RE: 9328 Highland Road- Commercial Building with Drive Thru – Final Site Plan and Final Engineering Plan - 1st Review

Subject: 9328 Highland Road
Final Site Plan Review
Zoned: General Business (GB) District

9328 HIGHLAND ROAD
PROPOSED COMMERCIAL BUILDING
WITH DRIVE-THROUGH

DRAWING: C-5

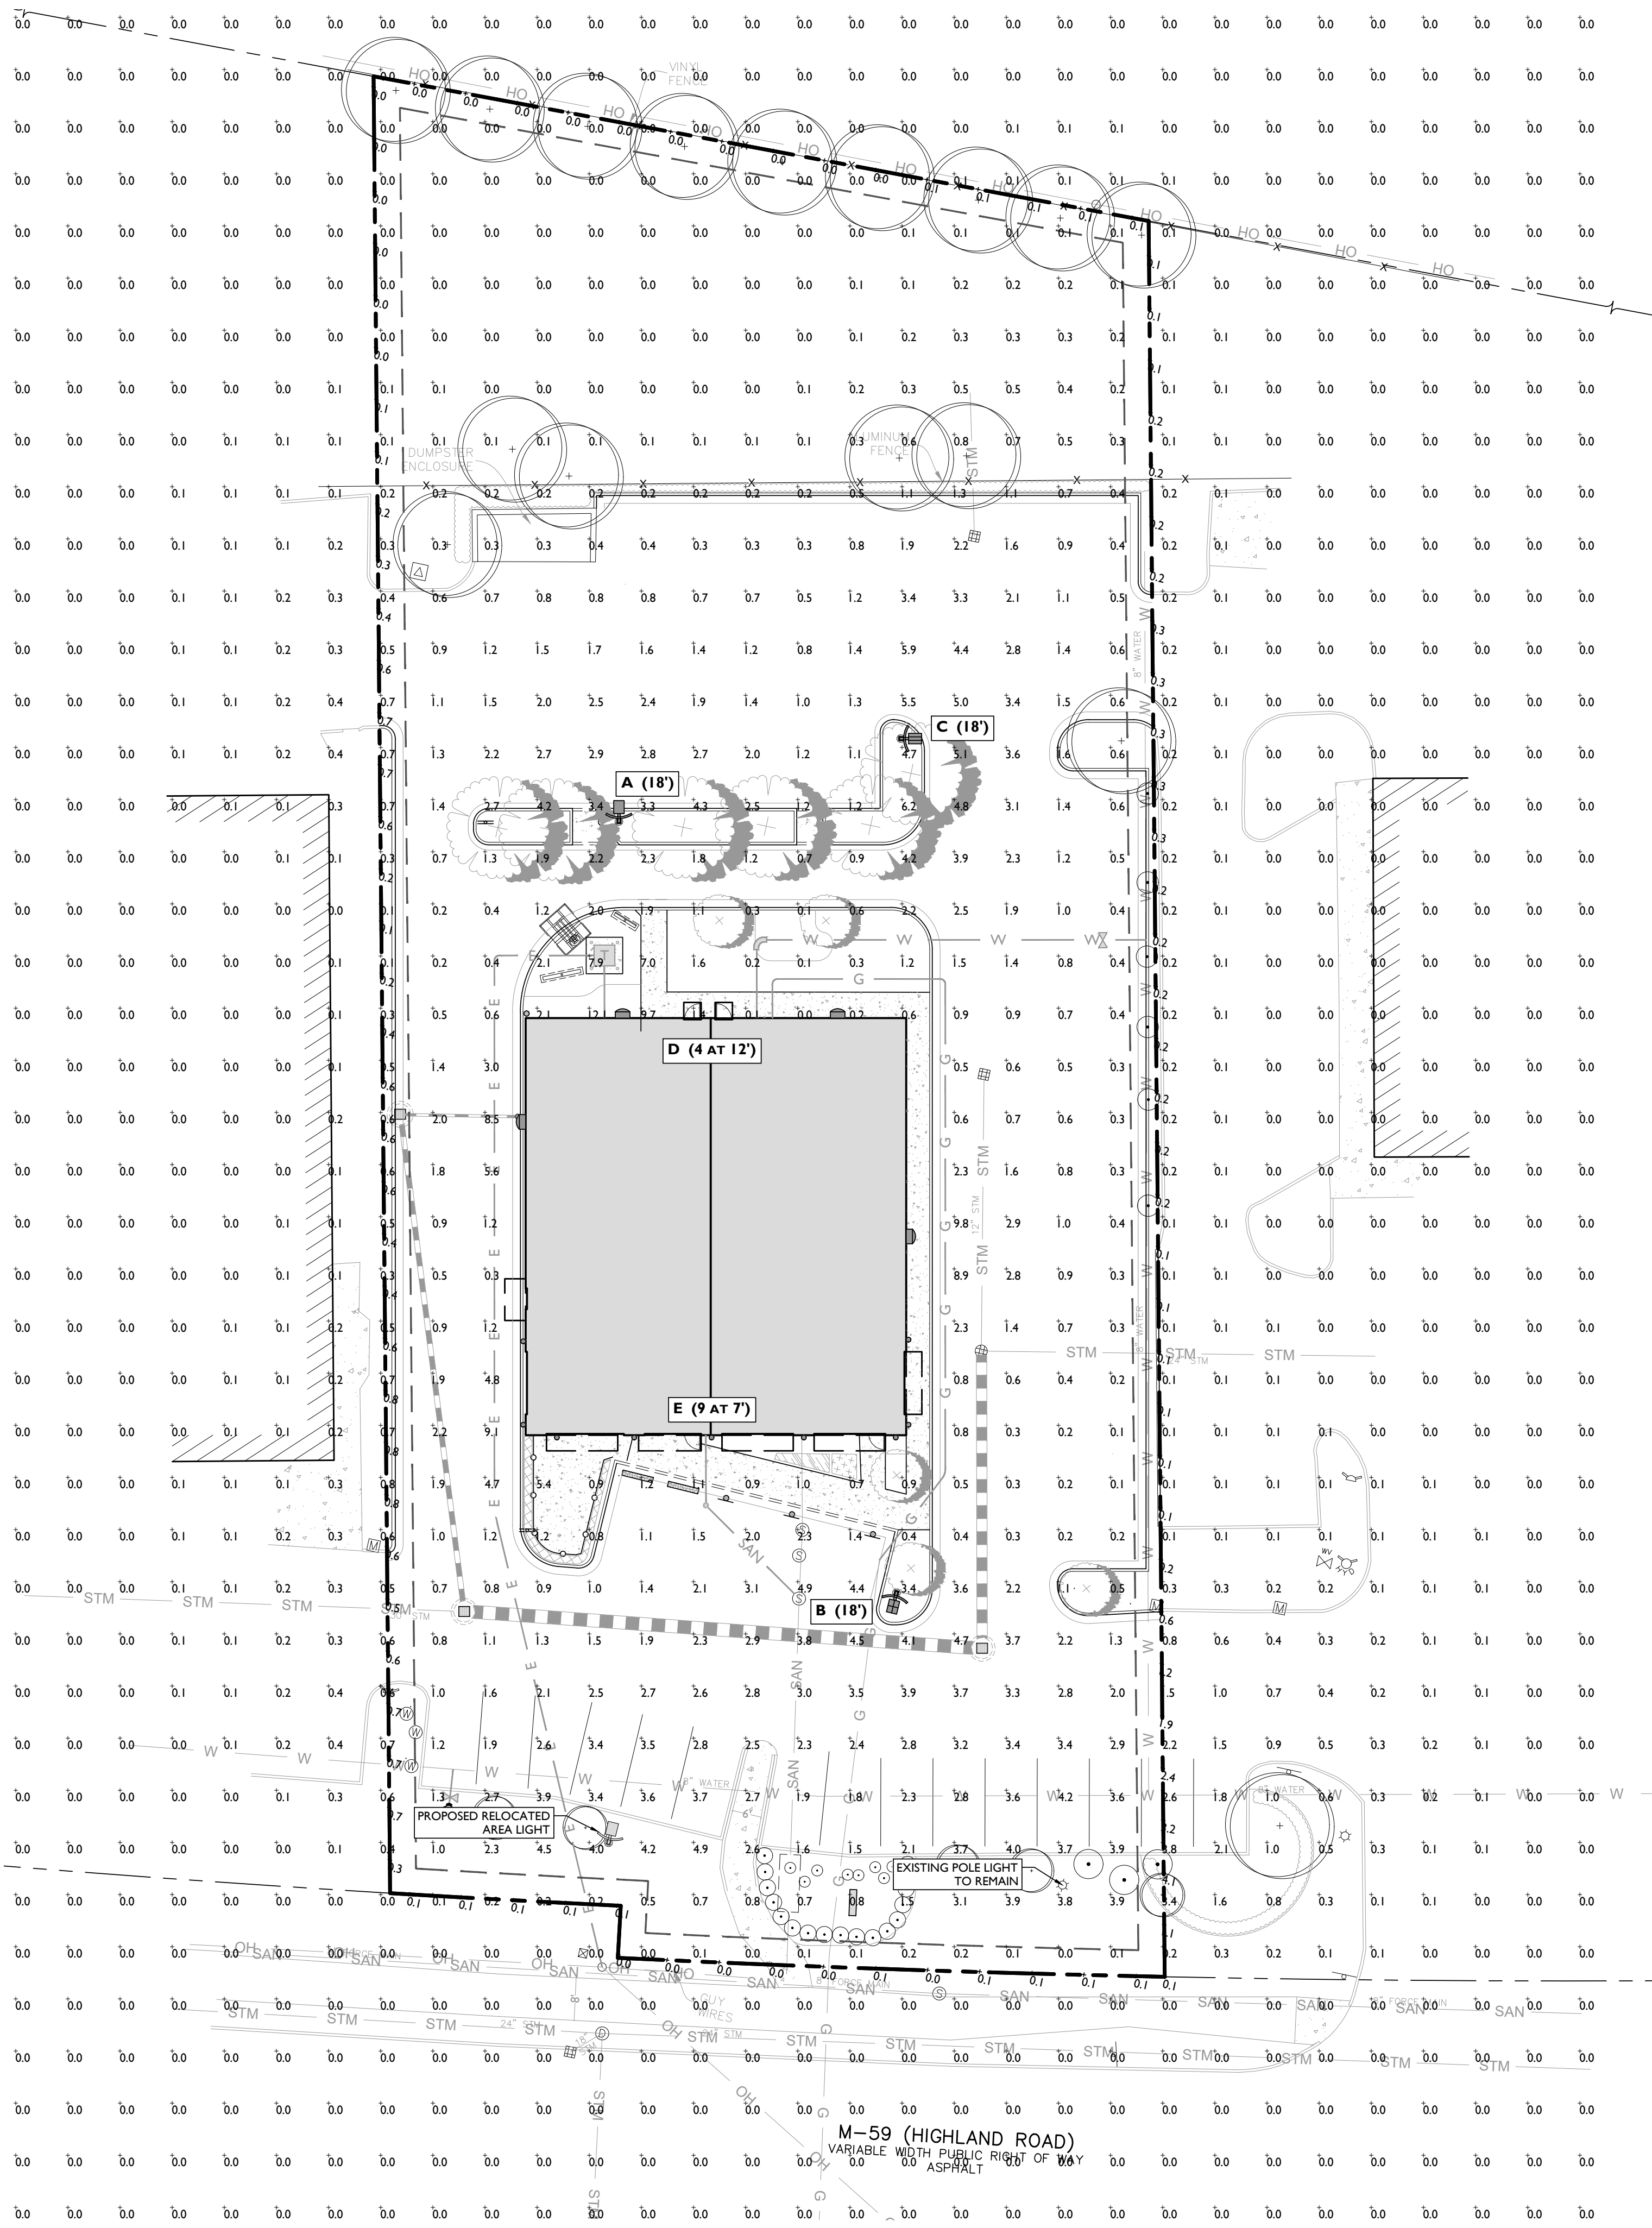
4. *The proposed relocation of the existing fire hydrant on drawing C-5 has Fire Marshal approval.*

PRELIMINARY NORTH ELEVATION
SCALE: 1/8" = 1'-0" 4

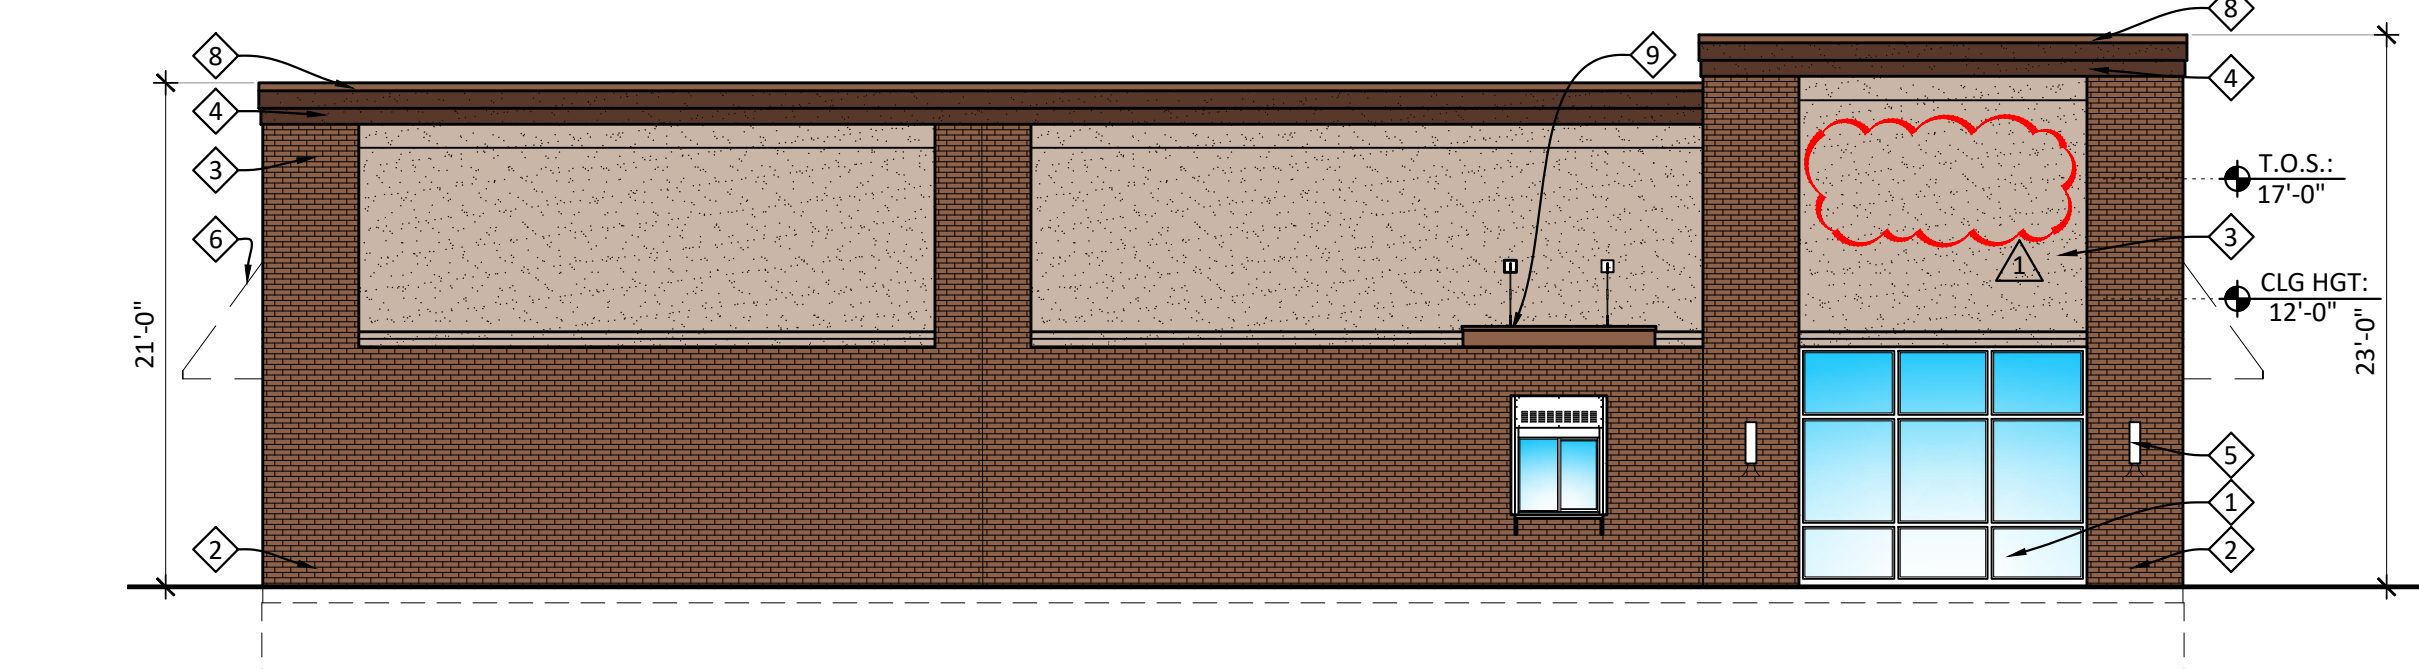
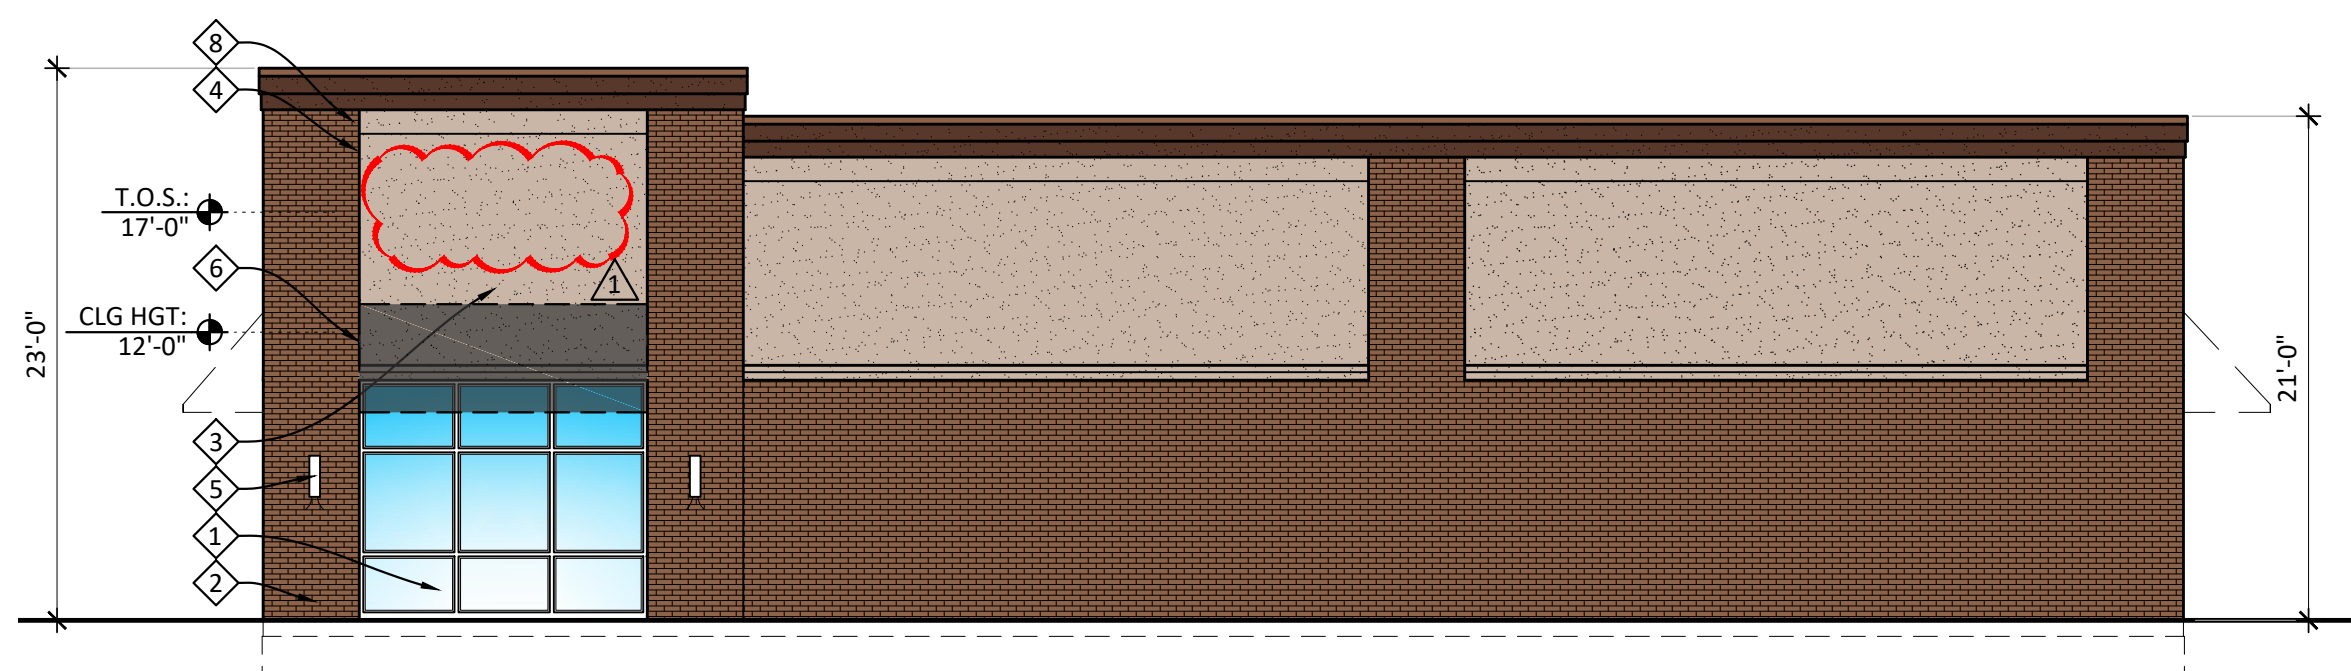
2. The Petitioner needs to provide calculations for the amount of the façade that meets the Zoning Ordinance requirements as well as the percentage of windows on the front façade (required to be at least 30%).
This has been provided on sheet PP-4. The percentage of durable materials ranges from 53% to 60%.

- The brick veneer was increased on each elevation, most notably the front elevation. Previously, the brick veneer (on the columns) only went up the building approximately half way, the current plan has the brick continuing up to the metal coping. The amount of EIFS was reduced on the other three elevations as well.
- The percentage of durable materials was noted on each elevation, on sheet PP-4.

Two wall signs are shown on the front elevation. A note has been added to the elevation plan, sheet PP-4, that signage will be submitted per tenant. The proposed location of the signage is in compliance with the Zoning Ordinance.
